Design for the proposed upgrade of Bankstown North Public School, in Bankstown, NSW

Stage 3 (Detailed design) Road Safety Audit

February 2021

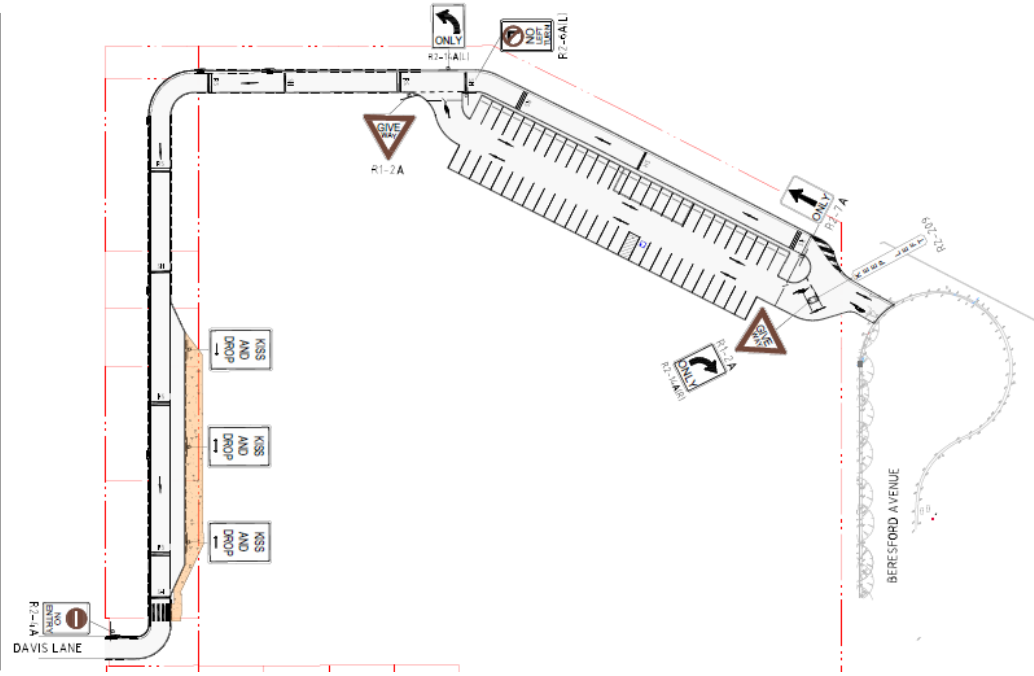
No.	Drawings / Approximate Location	Description of findings	Risk rating (likelihood/severity)
1	C10.01 / Zebra crossing on the circulation roadway	<p>'Pedestrian Crossing' (R3-1) signs are missing at both sides of the proposed Zebra crossing, so to face and alert egress drivers about the presence of Zebra crossing and pedestrians on it, as it is required in accordance with AS 1742.10-2009 (refer to Figure 4.1).</p> <p>Without the signs in place, some drivers could easily overlook the Zebra crossing, thus increasing the chance for a pedestrian to be struck by a vehicle on it.</p>  <p>Figure 4.1</p>	Intolrable (Probable / Serious)

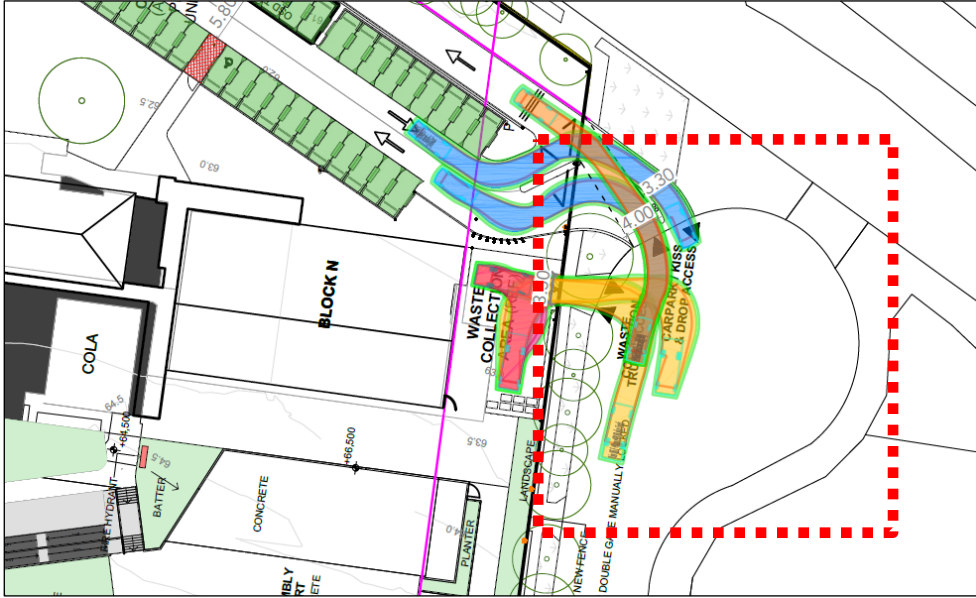
No.	Drawings / Approximate Location	Description of findings	Risk rating (likelihood/severity)
2	ptc-003 / Cul-de-sac on Beresford Avenue	<p>'No Stopping' zone is <u>not</u> proposed in the cul-de-sac on Beresford Avenue (refer to Figure 4.2).</p> <p>Therefore, there is nothing in place to prevent vehicles from stopping and/or parking within the cul-de-sac, thus obstructing access and/or exit from the car park, and mutual visibility between vehicles which are exiting the car park and vehicles traveling on Beresford Avenue toward the car park.</p> <p>Currently, 'No Stopping' zone is signposted, but limited only to school days and only between 2.30pm and 4.00pm (refer to Photo 4.1), while the car park would be used in the morning, too, as well as during the rest of a weekday, and, perhaps, on [some] weekends.</p>  <p>Figure 4.2</p>	<p>Medium (Probable / Limited)</p>
